Pending proposals for amendments to existing UN Regulations submitted by GRE and GRSG

Proposal for Supplement 16 to the 06 series of amendments to UN Regulation No. 48 (Installation of lighting and light-signalling devices)

Submitted by the Working Party on Lighting and Light-Signalling*

Annex 1, item 9.22., amend to read:

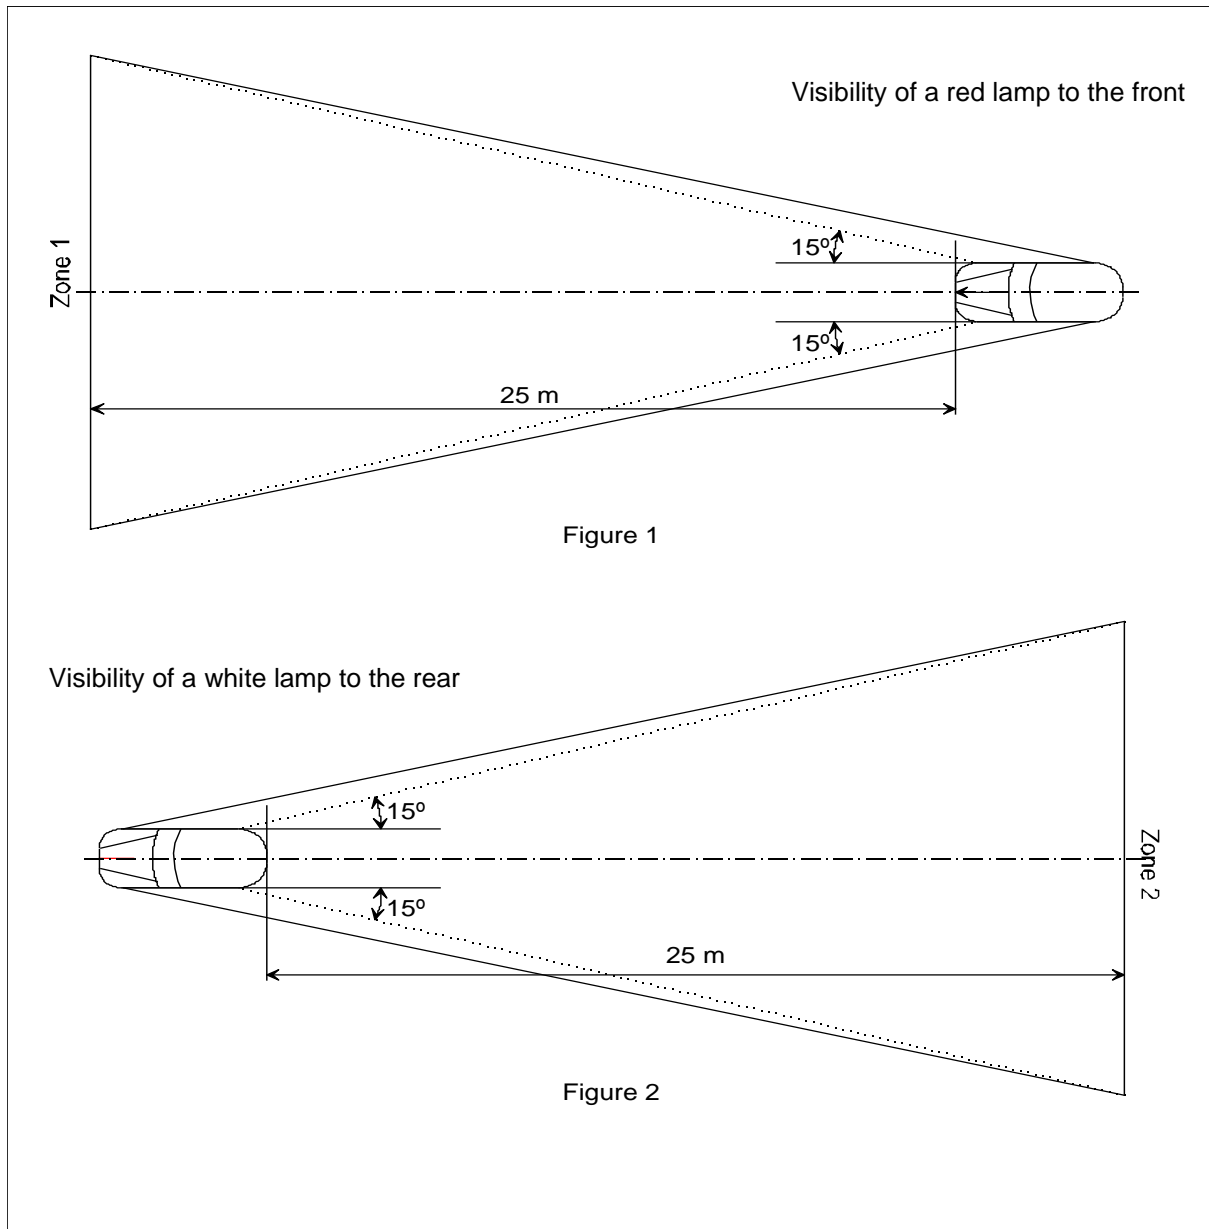
“9.22.	Adaptive front lighting system (AFS):	yes/no ²
9.22.1.	Main-beam ADB	yes/no ²
9.22.1.1.	Main-beam ADB + Driver Assistance Projection	yes/no ² ”

“Annex 4

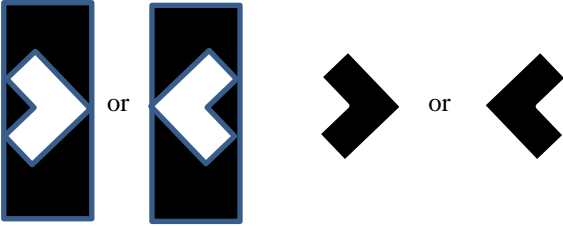
In their respective planes, the zones 1 and 2 explored by the eye of the observer are bounded:

- In height, by two horizontal planes 1 m and 2.2 m respectively above the ground;
- In width, by two vertical planes which, forming to the front and to the rear respectively an angle of 15° outwards from the vehicle's median longitudinal plane, pass through the point or points of contact of vertical planes parallel to the vehicle's median longitudinal plane delimiting the vehicle's overall width; if there are several points of contact, the foremost shall correspond to the forward plane and the rearmost to the rearward plane.”
